CONSTRUCTION DOCUMENTS  
GRANDVIEW RESERVE FILING NO. 1  
4 SITE INVESTMENTS, LLC (D.R. HORTON)  
SF-22-XXX  
EASTONVILLE RD & REX RD  
EL PASO COUNTY, FALCON, CO 80831

OVERALL SHEET

KATE MEADOW LN (B) - PUBLIC 50' R.O.W.  
25 MPH DESIGN SPEED (LOCAL)  
SCALE: 1"=30'

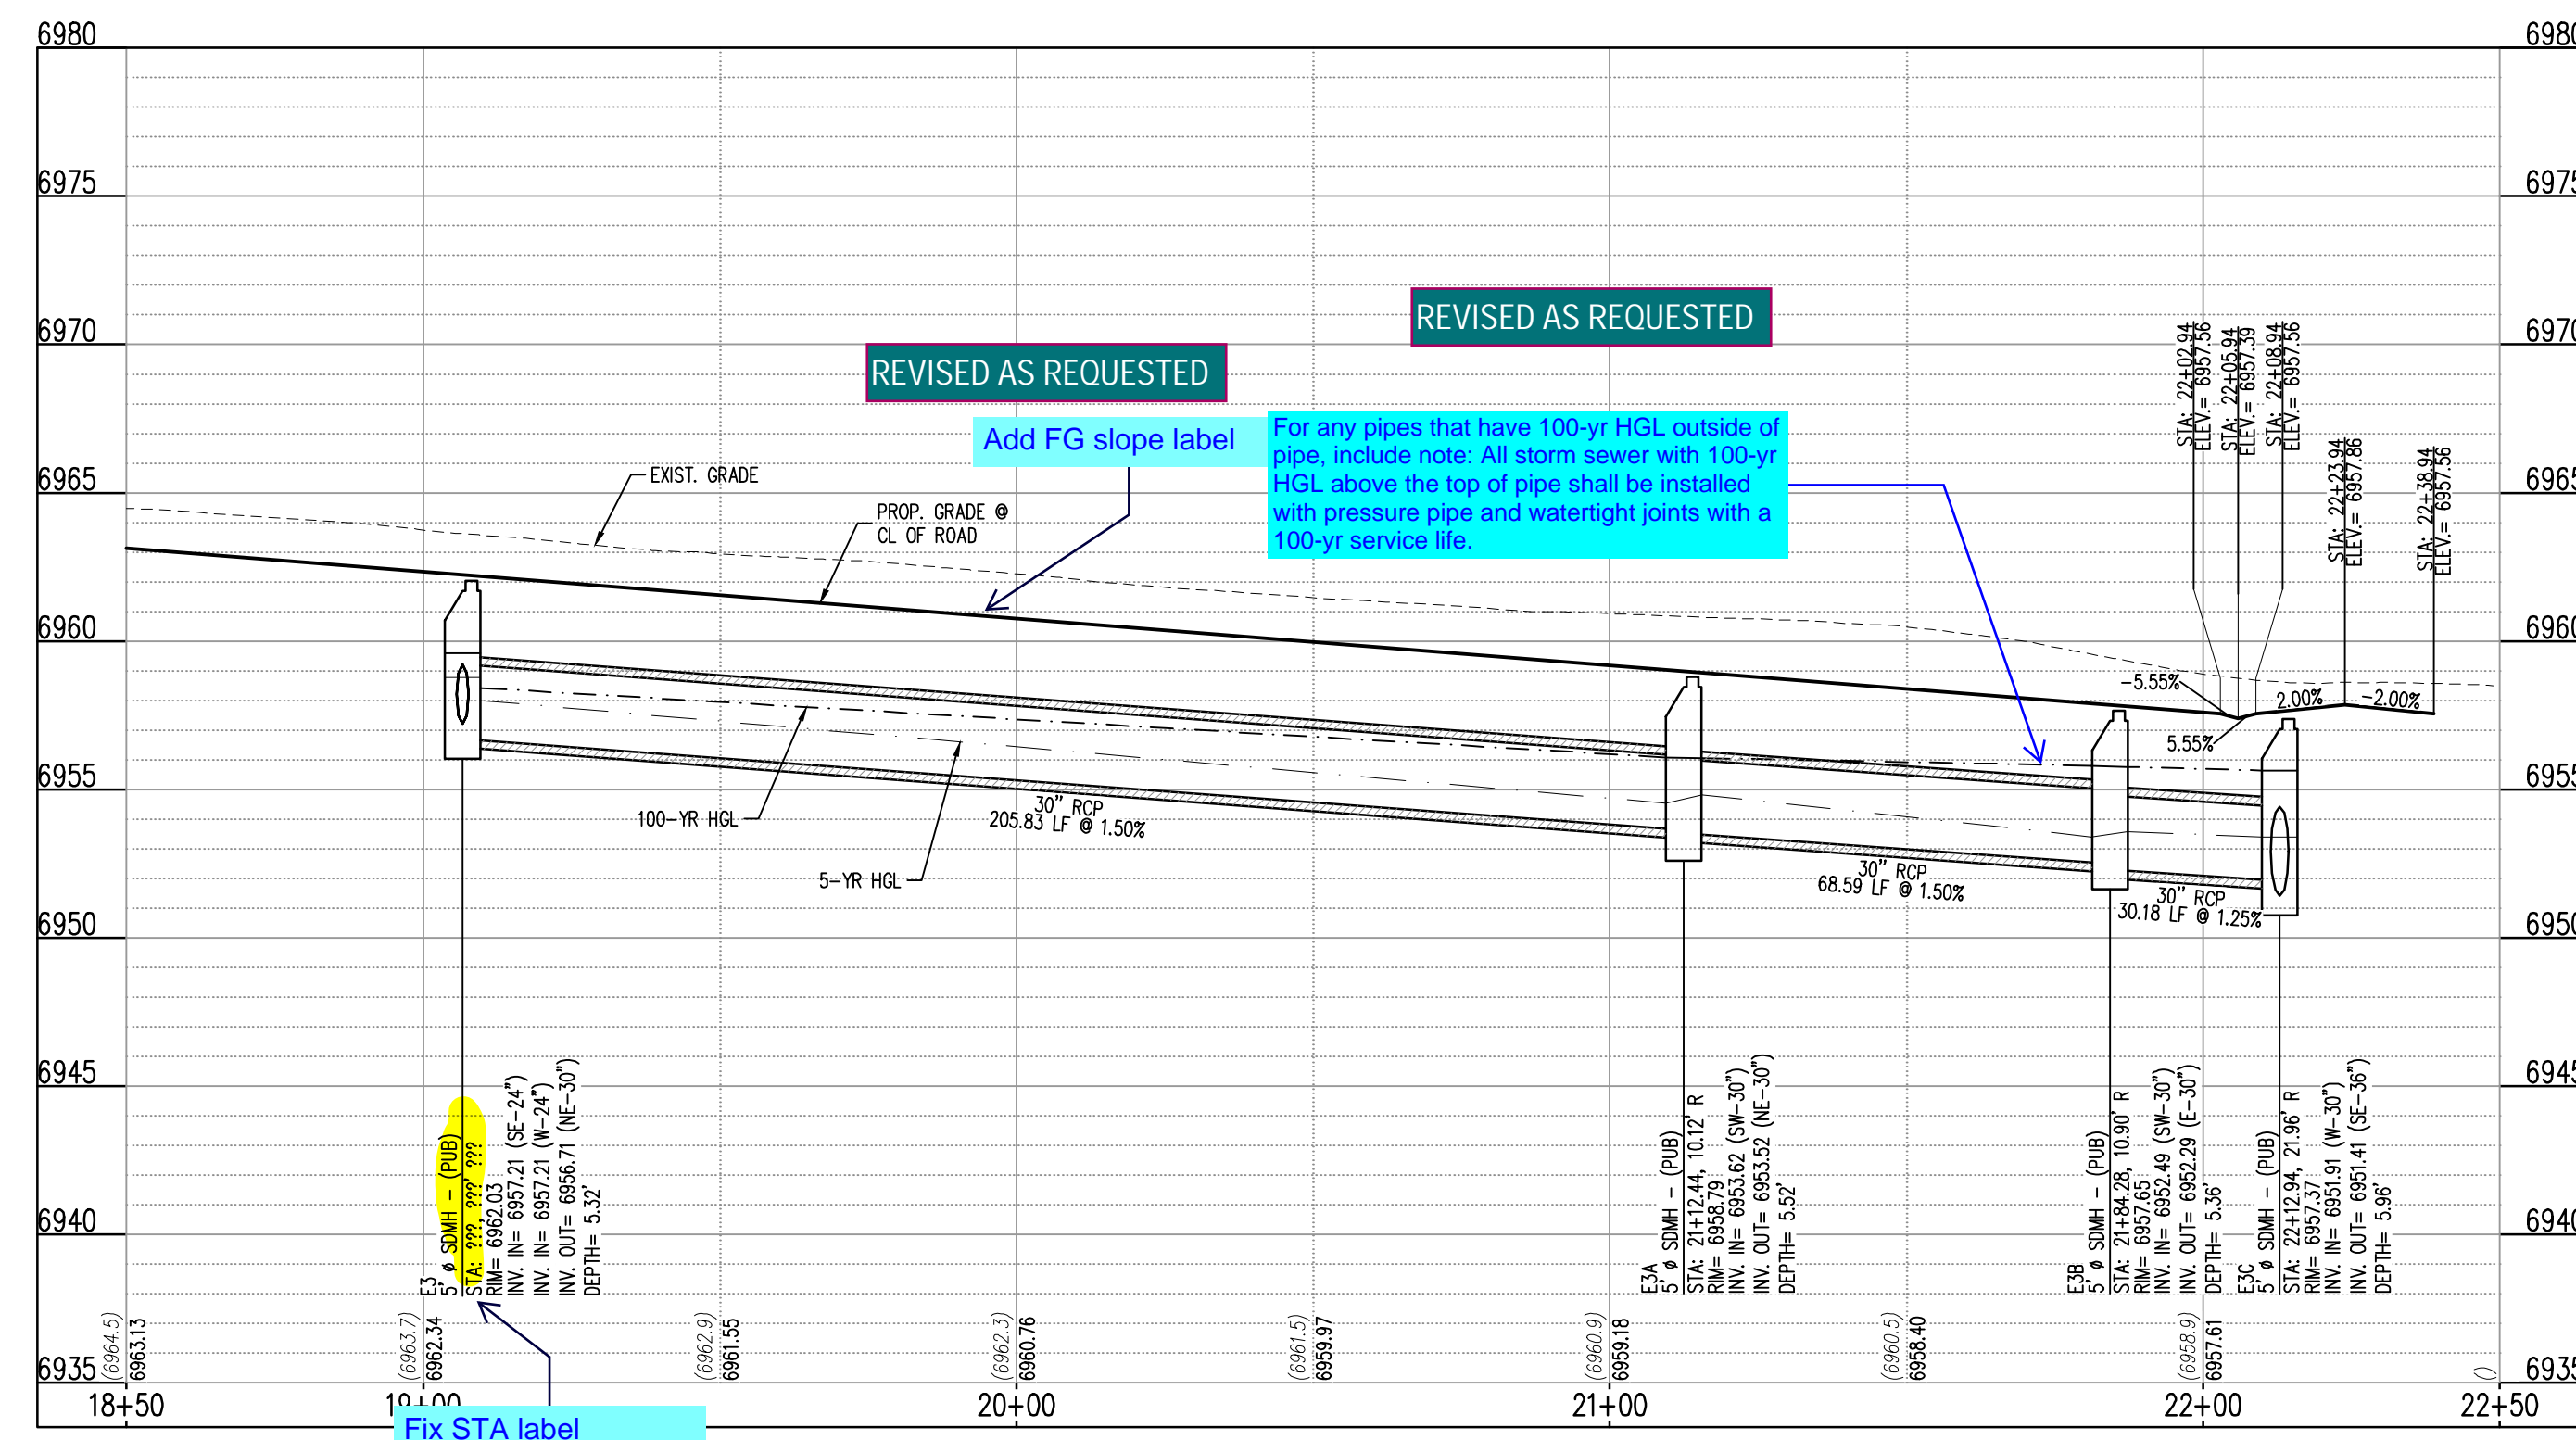
**REVISED AS REQUESTED**  
REVISED AS REQUESTED  
Add FG slope label  
For any pipes that have 100-yr HGL outside of pipe, include note. All storm sewer with 100-yr HGL above the top of pipe shall be installed with pressure pipe and watertight joints with a 100-yr service life.  
Fix STA label

FARM CLOSE CT (C) - PUBLIC 50' R.O.W.  
25 MPH DESIGN SPEED (LOCAL)  
SCALE: 1"=30'

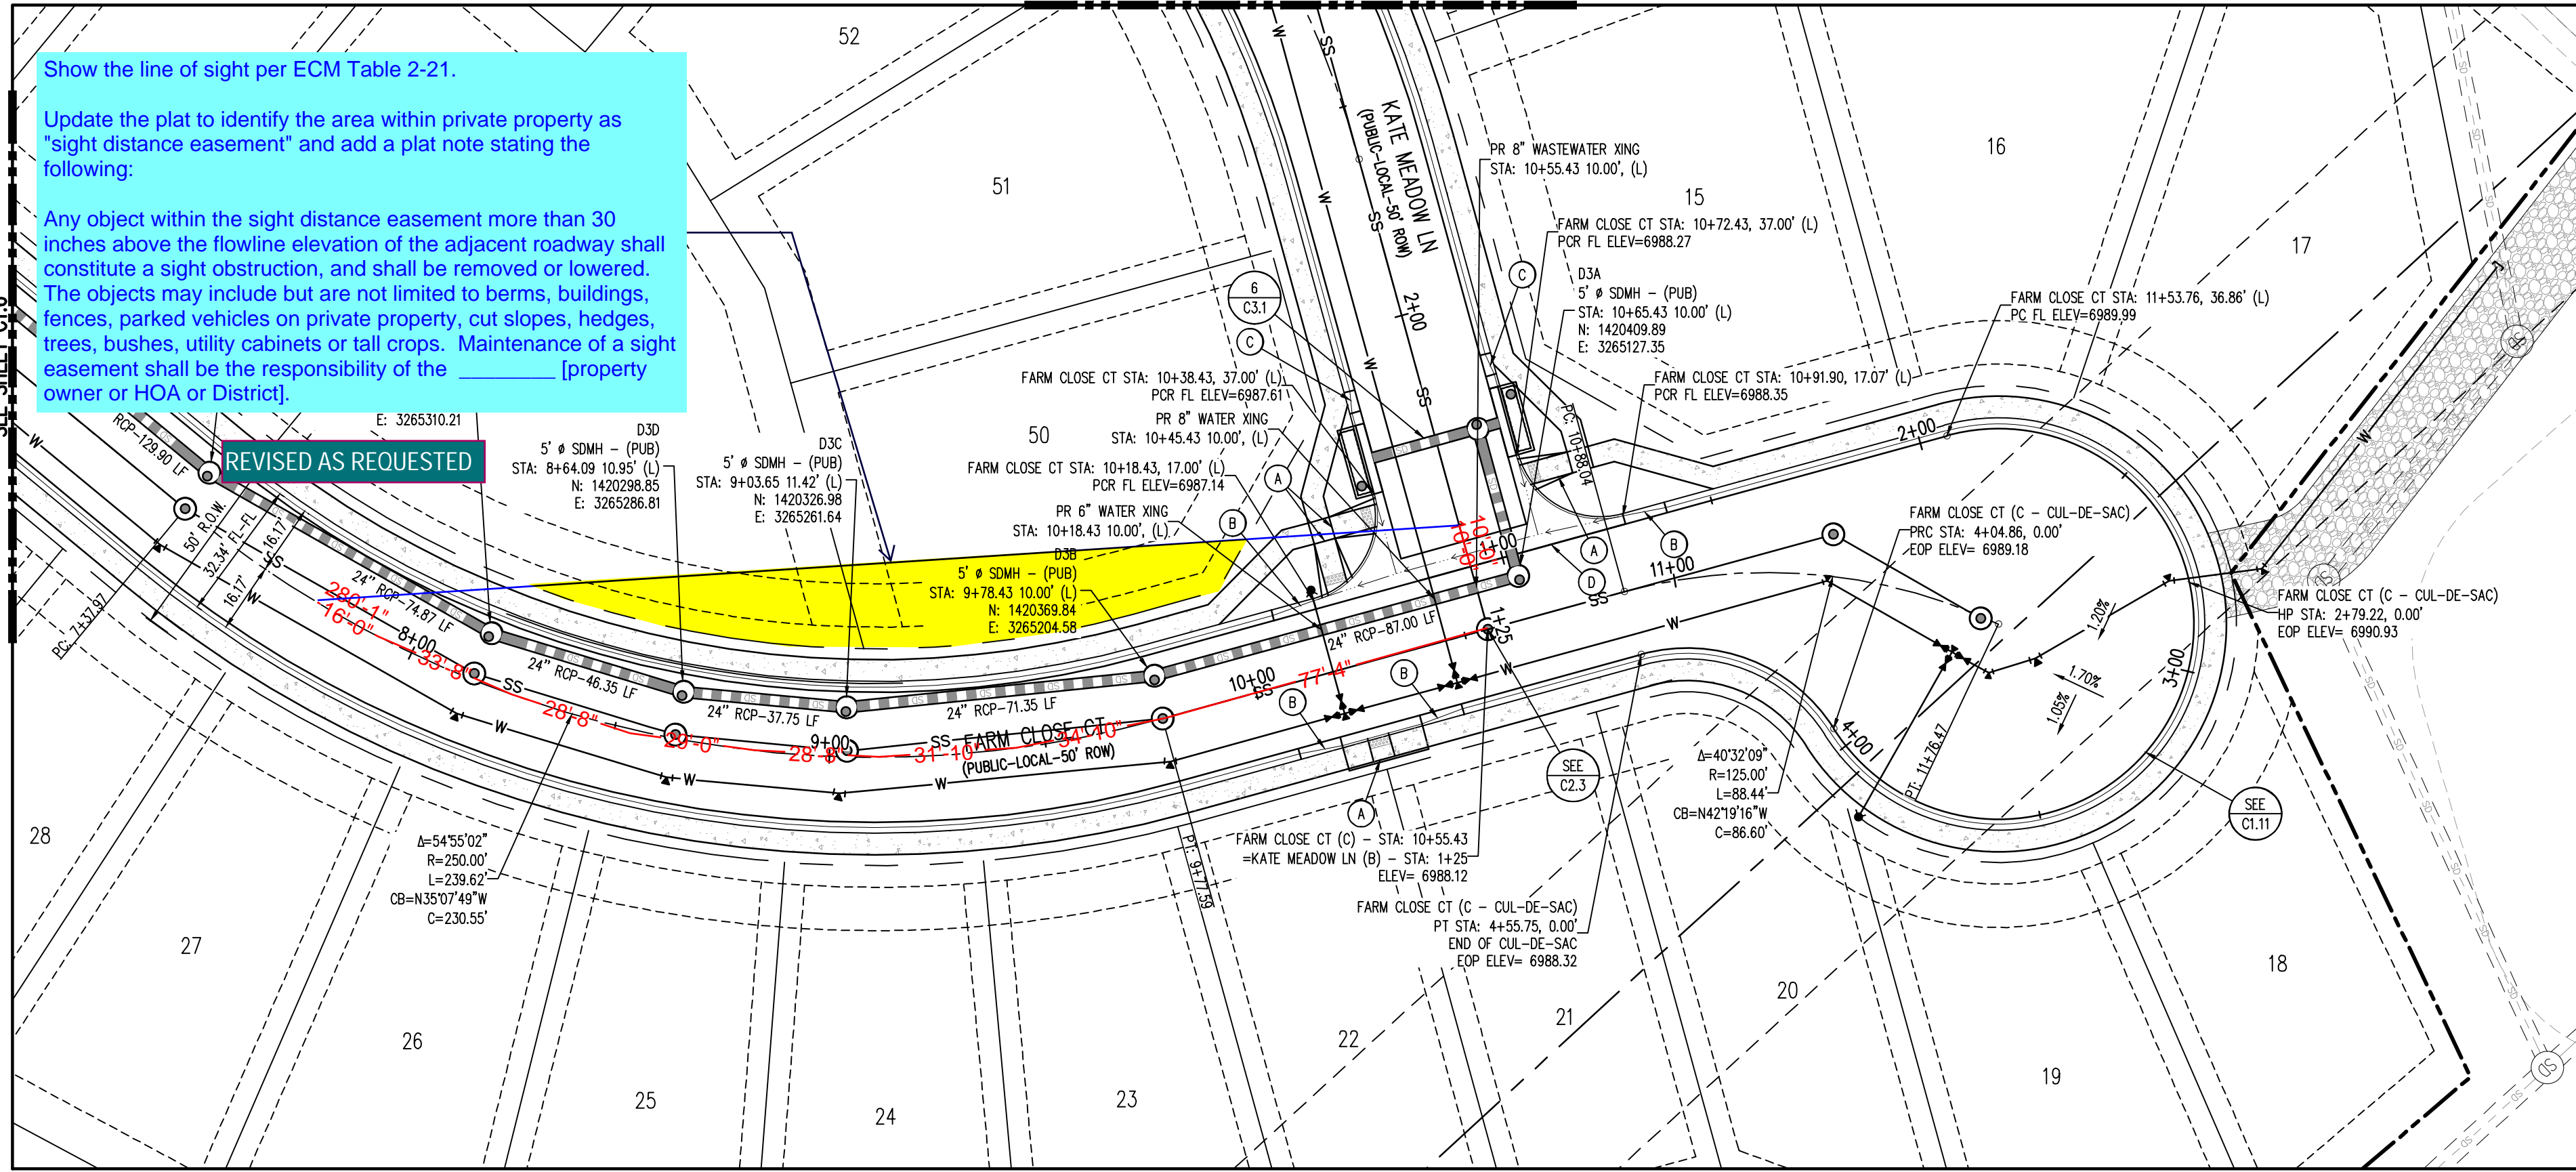
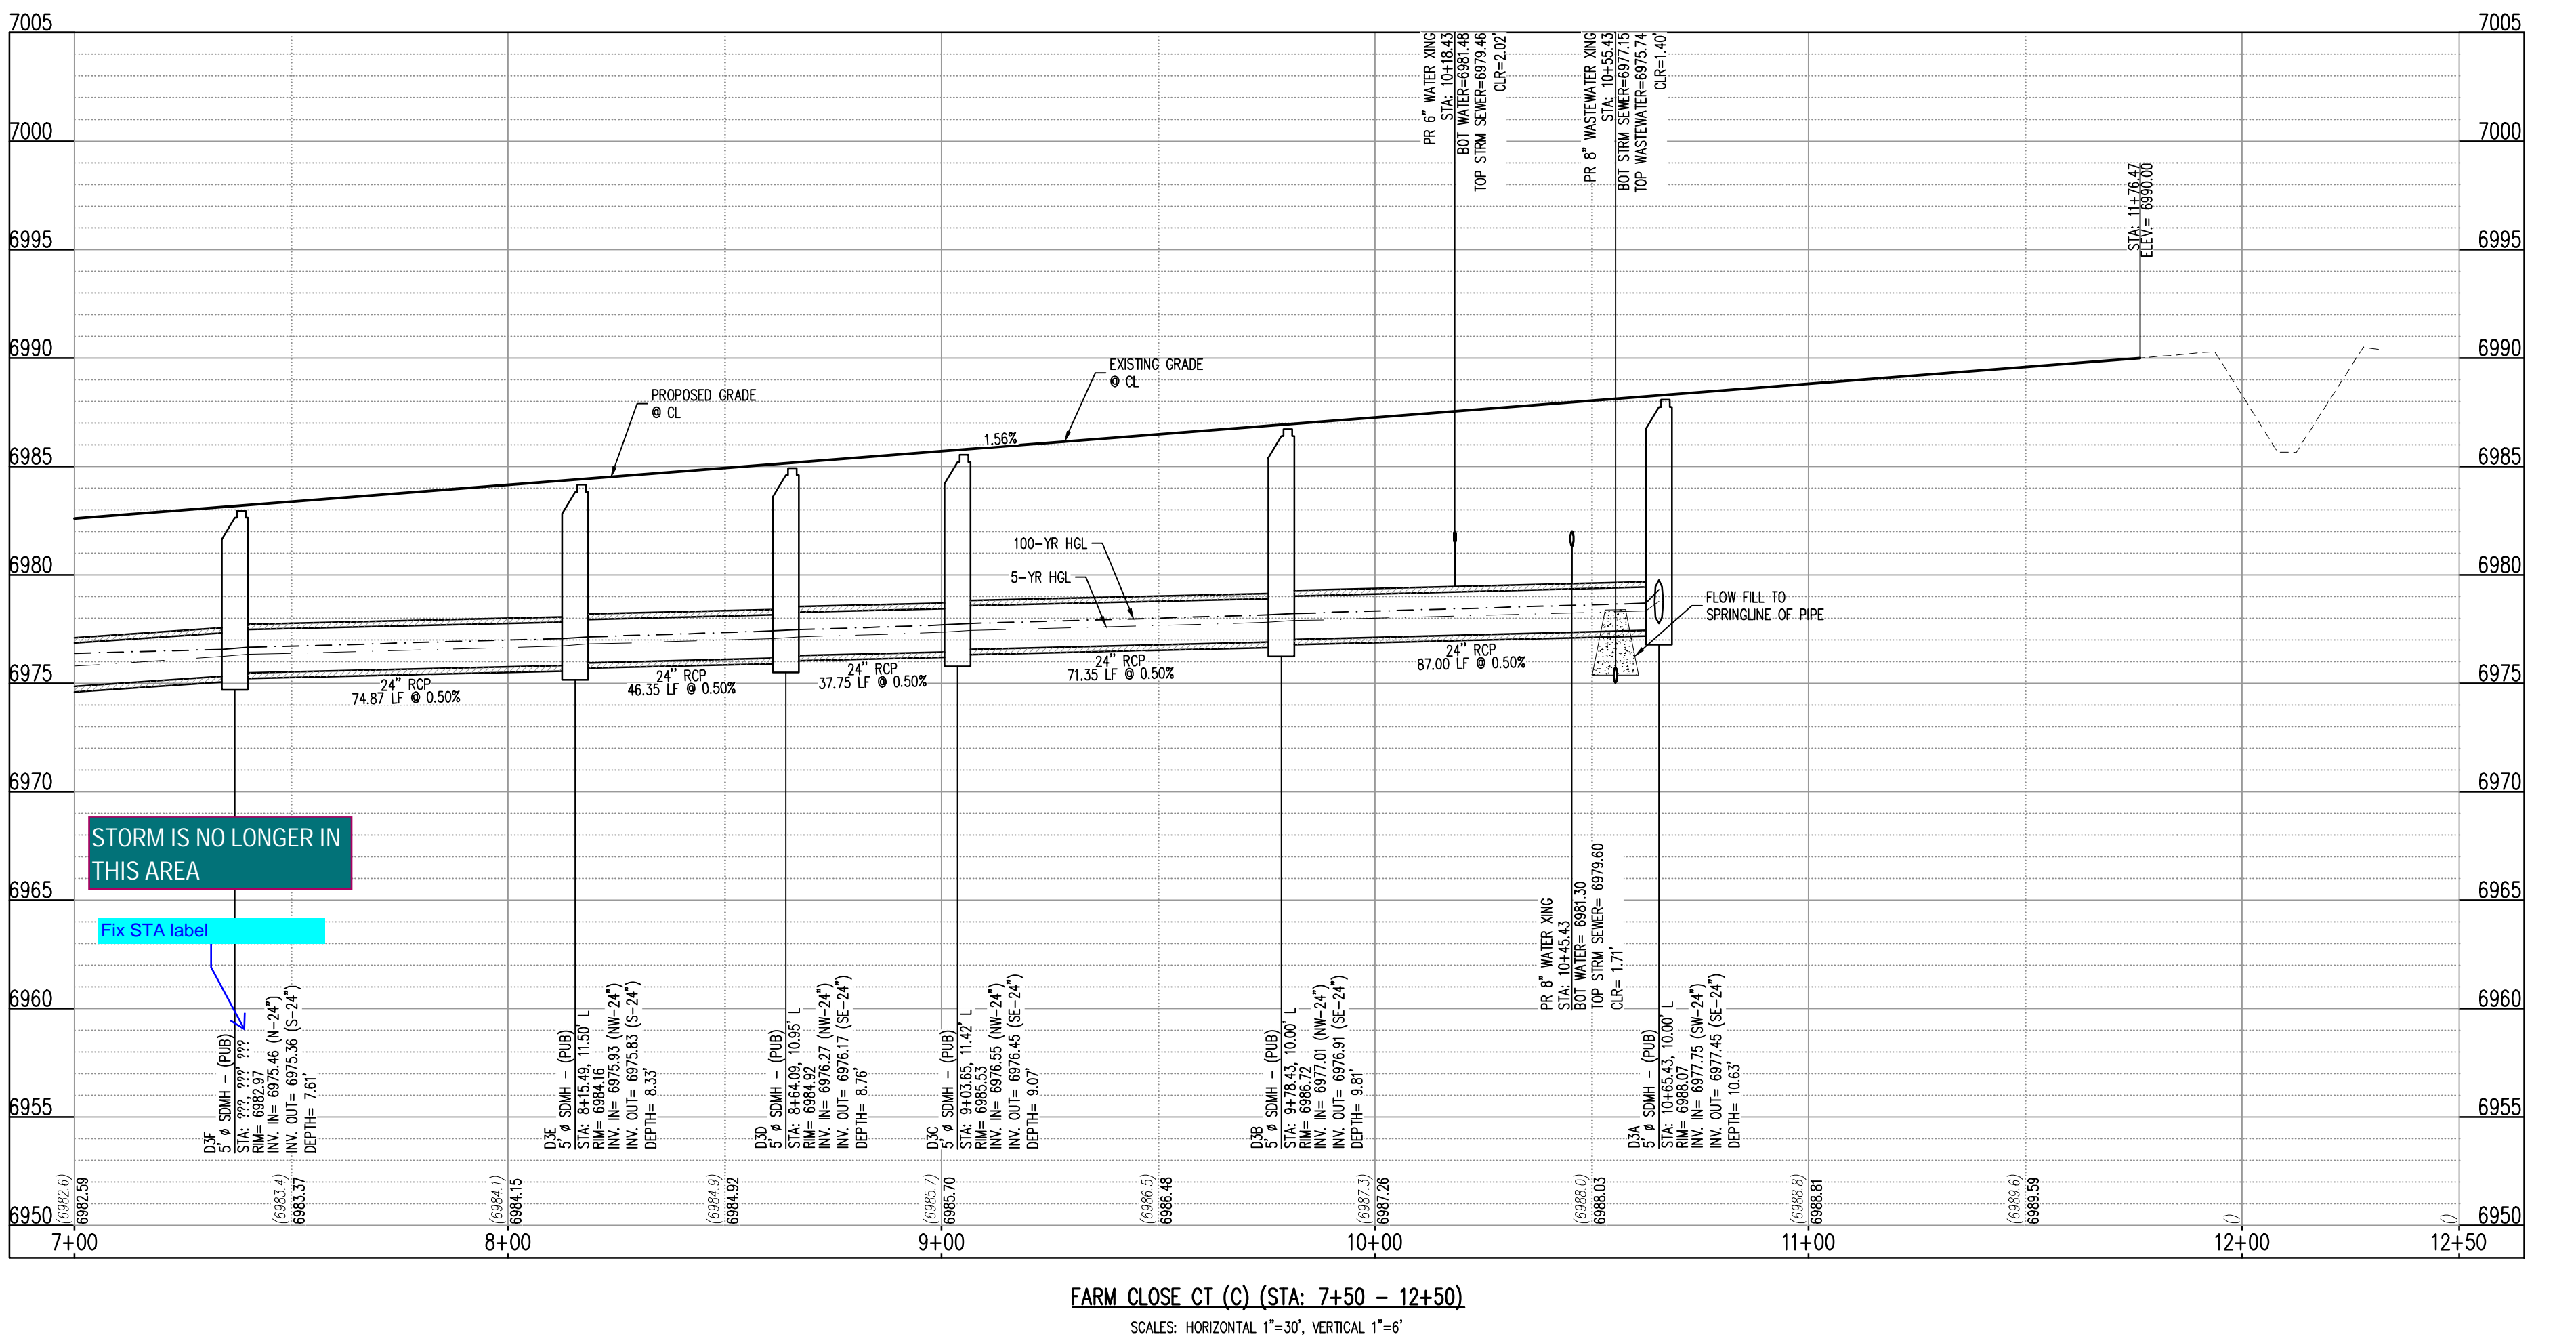
Show the line of sight per ECM Table 2-21.  
Update the plat to identify the area within private property as "sight distance easement" and add a plat note stating the following:  
Any object within the sight distance easement more than 30 inches above the flowline elevation of the adjacent roadway shall constitute a sight obstruction, and shall be removed or lowered. The objects may include but are not limited to berms, buildings, fences, parked vehicles on private property, cut slopes, hedges, trees, bushes, utility cabinets or tall crops. Maintenance of a sight easement shall be the responsibility of the \_\_\_\_\_ [property owner or HOA or District].
